Serial No.: 09/841,451

For: MULTIPLE FUNCTION AIRWAY
ADAPTER

LETTER TO THE CHIEF DRAFTSMAN

Fig. 1

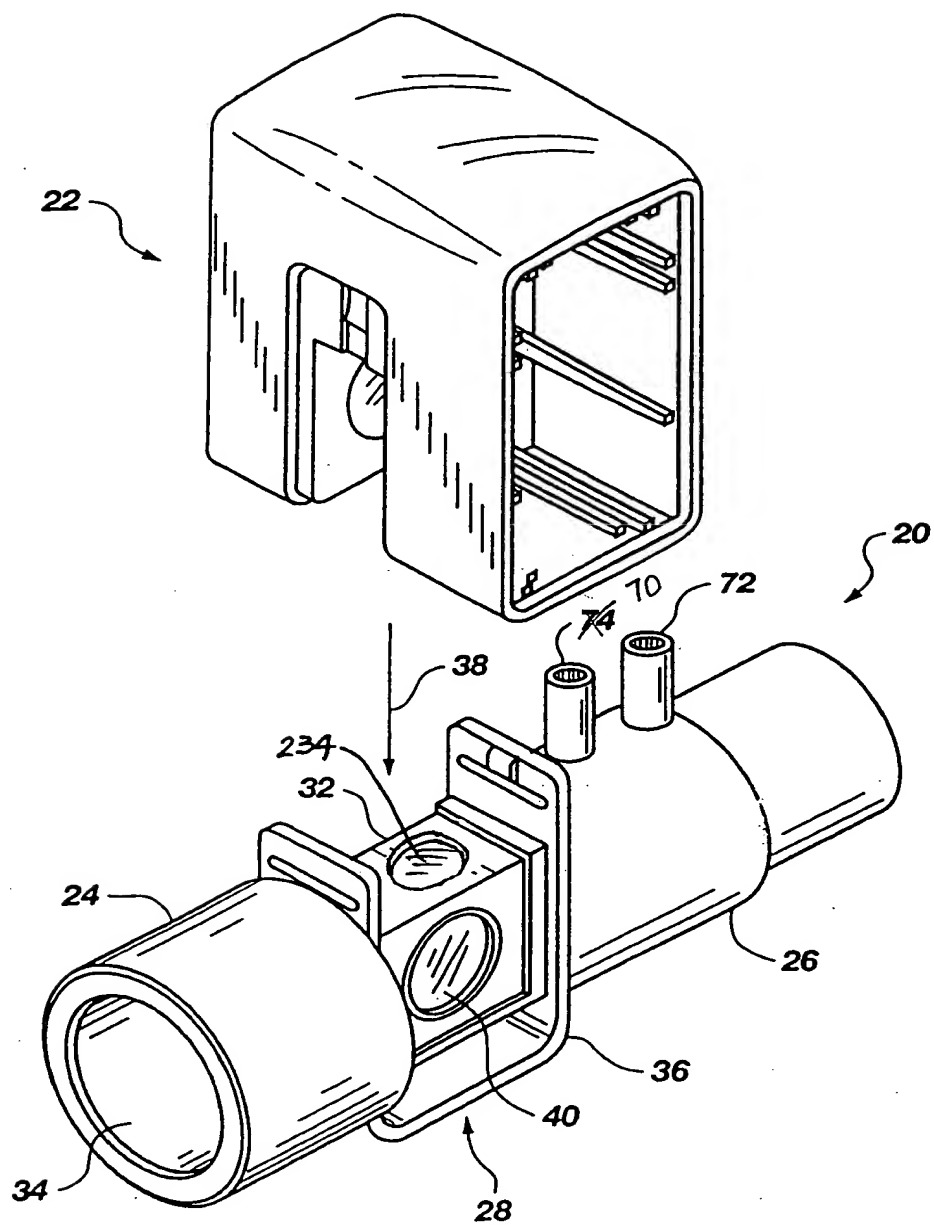
Applicants submit herewith revised FIGS. 1-2A, 4-7, 10, 12-15, 17, and 20 which correct errors in the drawings. Specifically, FIG. 1 has been revised to change reference numeral 74 to 70; FIG. 2 has been revised to change reference numeral 74 to 70; FIG. 2A has been revised to change reference numeral 254 to 234, to change reference numeral 74 to 70, to add reference numeral 26 with appropriate lead line, and to change the lead line of reference numeral 24; FIG. 4 has been revised to add reference numerals 33, 34 and 242 with appropriate lead lines; FIG. 5 has been revised to add reference numerals 24, 26 and 34 with appropriate lead lines; FIG. 6 has been revised to add reference numeral 33 with appropriate lead line; FIG. 7 has been

FIG. 10

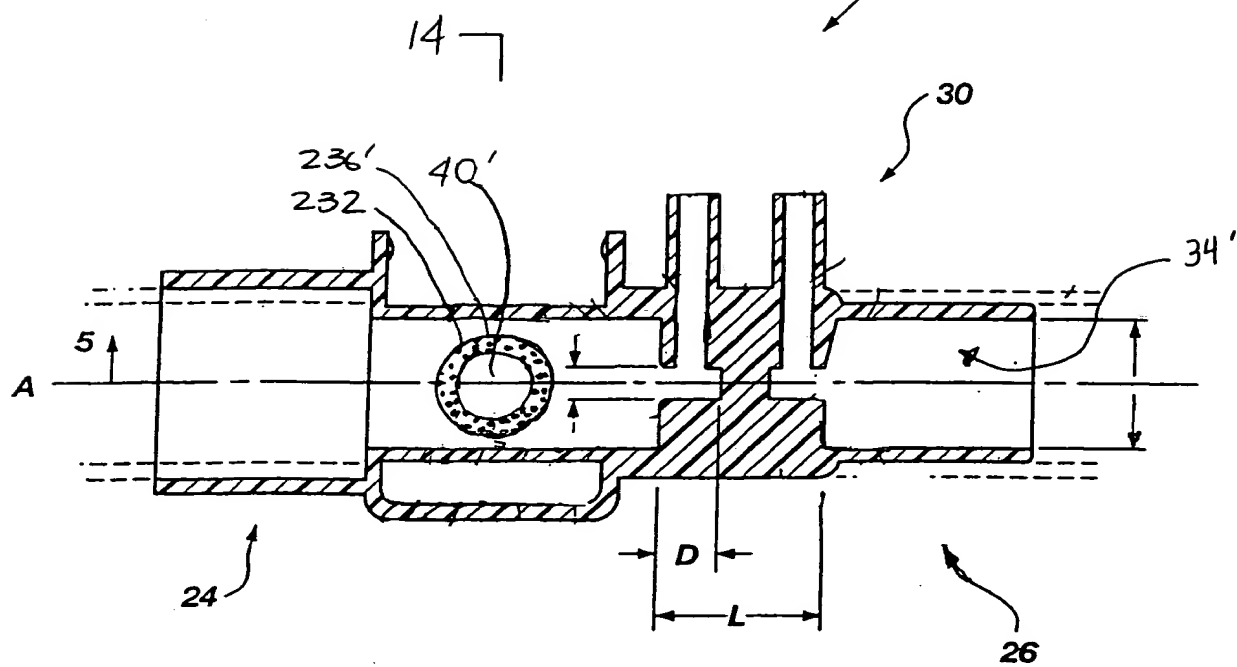
revised to add reference numerals 22a" and 22b" with appropriate lead lines; FIG. 10 has been revised to change reference numeral 42 to 142; FIG. 12 has been revised to change reference numeral 42 to 142; FIG. 13 has been revised to change reference numeral 20 to 20' and to add reference numeral 34' with appropriate lead line; FIG. 14 has been revised to change reference numeral 22 to 22', 256 to 256', 258 to 258' and to add reference numeral 34' to the center of the drawing; FIG. 15 has been revised to change reference numerals 92 to 21, 24 to 24', 20 to 20' and 74 to 70; FIG. 17 has been revised to add reference numeral 143 with appropriate lead line, to change the lead line from reference numeral 138, and to change reference numerals 142 to 141, 120 to 125 and 140 to 145; and FIG. 20 has been revised to add reference numerals 110 and 143 with appropriate lead lines, to change the bottom occurrence of reference numeral 140 to 145 and to delete the top occurrence of reference numeral 140 and accompanying lead line. Attached is a copy of the drawings with the proposed changes marked in red.
